Office Action Summary	Application No. 10/563,040	Applicant(s) BERTHOLD ET AL.	
	Examiner DANIEL ROJAS	Art Unit 4125

DETAILED ACTION

Figure 1: *Applicant's Invention*

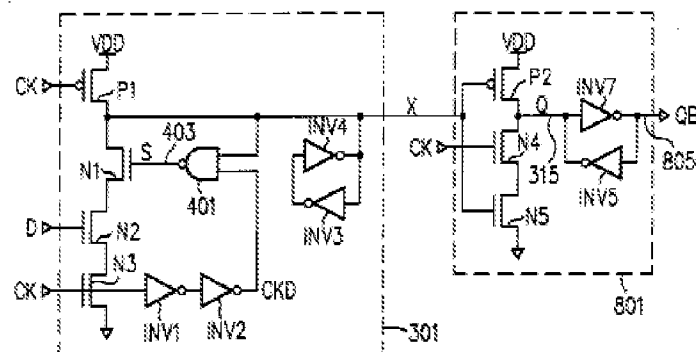
7. Claim 30 is rejected under 35 U.S.C. 112, second paragraph, as being indefinite for failing to particularly point out and distinctly claim the subject matter which applicant regards as the invention. The applicant's drawings do not show four controllable switches being connected in series with each other between the circuit node and the reference potential node, as stated in the claim. However, for the purposes of examination, examiner will interpret this claim as "the first, second, third, and fourth controllable switches being connected in series with one another being a voltage supply and the reference potential node."

Figure 2: *Klass's invention (US Patent No. 5,917,355, Figure 8)*

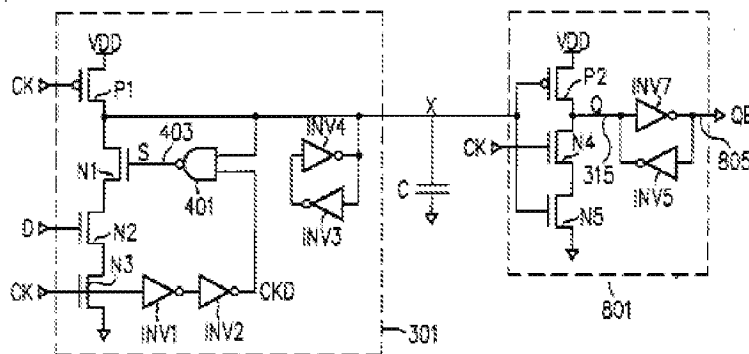
11. For claim 23, Klass's invention comprises a signal delay circuit (INV1 and INV2, Figure 2 above) configured to generate a delayed clock signal (CKD, Figure 2 above) corresponding to the clock signal (CK, Figure 2 above) delayed by a time delay (INV1 and INV2 in Figure 2 above form a buffer with a fixed time delay) but fails to teach the said circuit node and capacitor with a programmable capacitance. However, examiner takes official notice that it is notoriously old and well known that a capacitor connected to ground at an output to any circuit serves as a filter. Therefore, it would have been obvious to one of ordinary skill in the art at the time of invention to include a capacitor directly connected between ground and node X of Klass's invention in order to filter
